**Subject: Report of Structural Engineering Evaluation – ADDENDUM 1
Second Elevated Floor Slab and Stage Framing
Italian Club
Ybor City
Tampa, Florida**

Attachments: Partial Plan – 2nd Elevated Floor Slab/Ballroom

PARTIAL PLAN - 2ND ELEVATED FLOOR SLAB/BALLROOM
N.T.S.

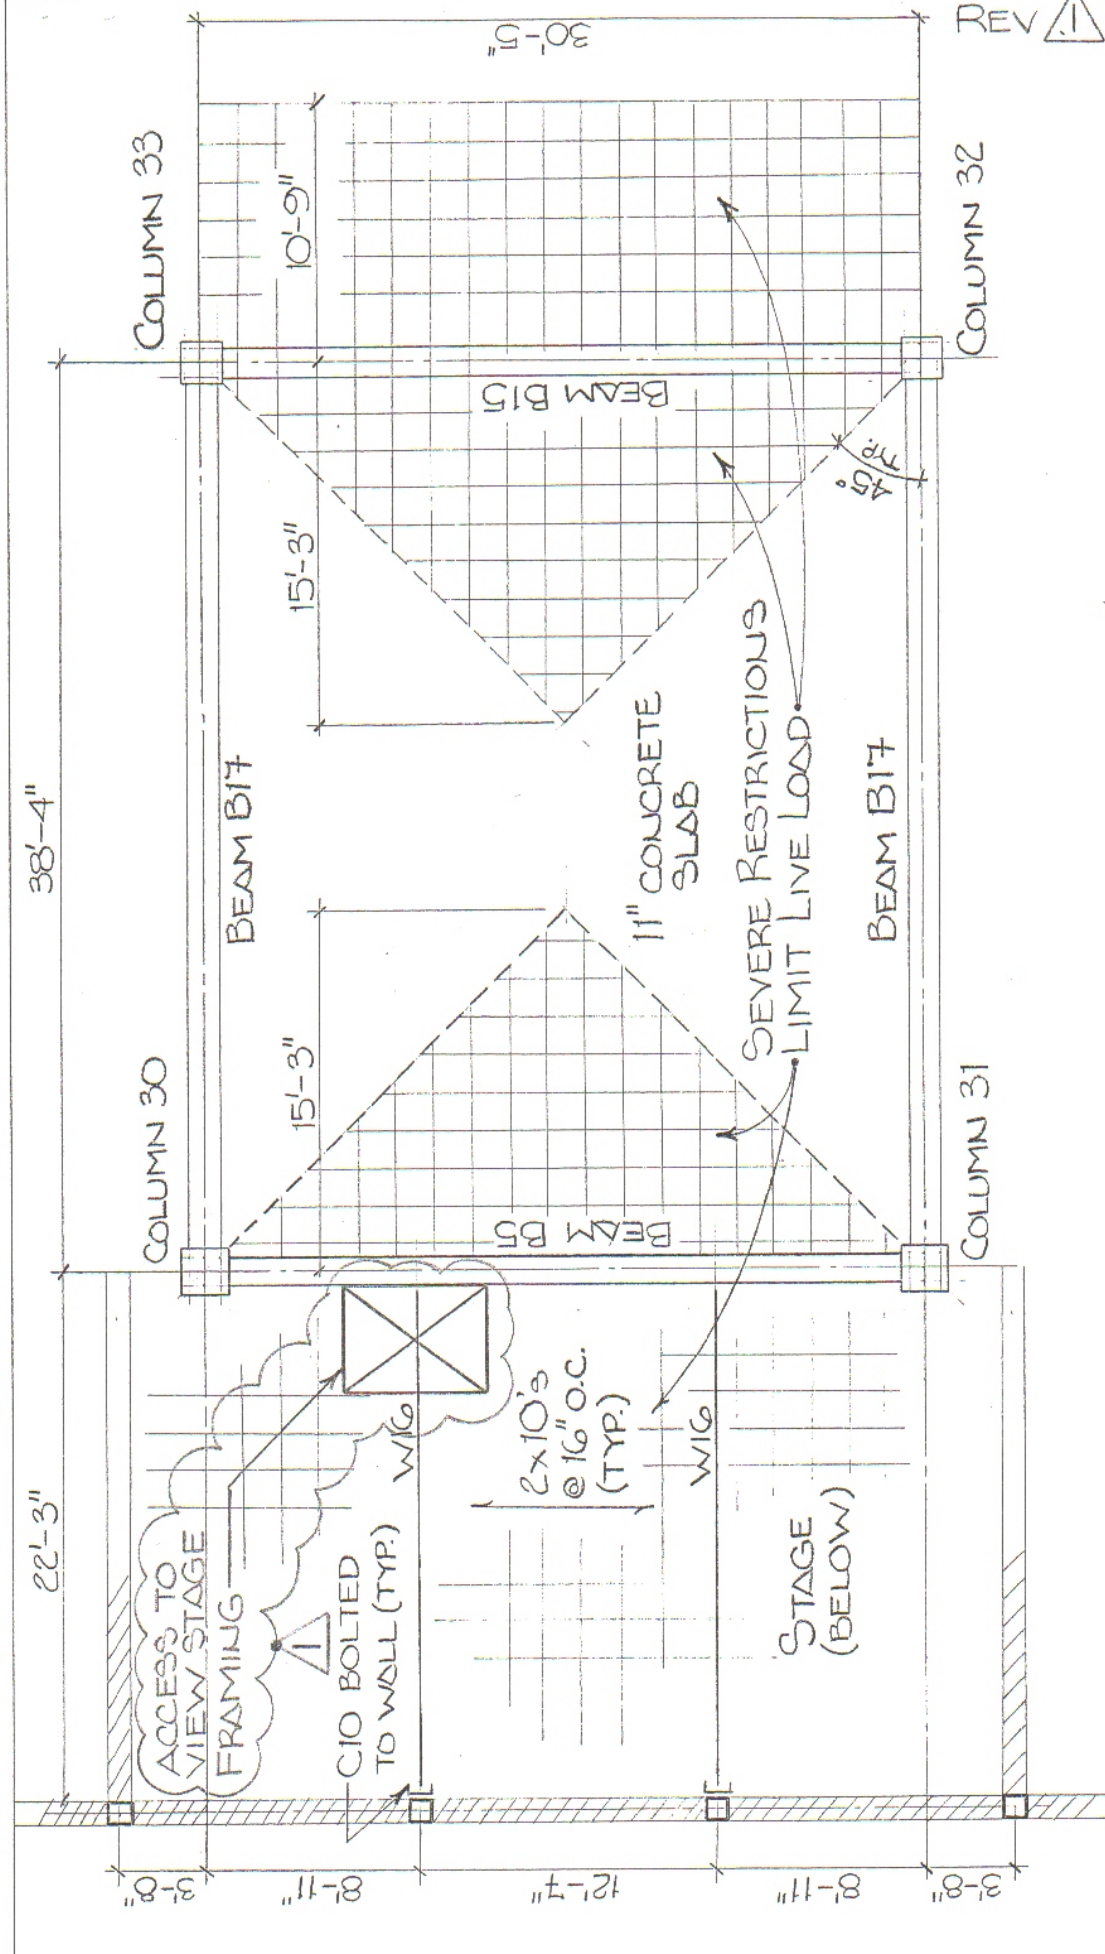
- c. The wide flange steel beams supporting the wood joists appear to connect into Beam B5, and BRSB has concerns with this beam (see item below).
- d. BRSB has concerns regarding Beam B5, which spans east-west between columns 30 and 31. This beam appears to have been originally designed for the partial support of the 11 inch thick concrete slab and its associated loading. The upper stage area was originally open to the stage below at the auditorium level. BRSB believes the additional stage framing and its associated loading significantly overstresses the beam beyond current building code requirements. No drawings or information are available for review regarding the stage framing, so BRSB is unable to determine if additional reinforcement was applied to Beam B5 before the additional stage area framing was installed.

- e. BRSB evaluated the two beams designated B17. These beams span north-south on the east and west edges of the 11-inch thick slab. Analyses show that the design capacity is less than that for factored loads, but greater than required for service loads.

- f. BRSB evaluated the beam designated B15. This beam spans east-west between columns designated 32 and 33 along the on the north edge of the 11-inch thick slab. Analyses show that the design capacity is less than required for service loads under the applicable building code.

In addition to the 3rd Floor Stage drawing review, BRSG recommends removing a portion of the floor deck above the stage area framing to visually observed Beam B5 and the connection of the stage framing to this beam. See attached Partial Plan for recommend location for access.

BRSG maintains our recommendations for not utilizing the ballroom area for dancing and severe restriction of use for the third floor ballroom at this time until the drawings for the 3rd Floor Stage area can be located and reviewed.
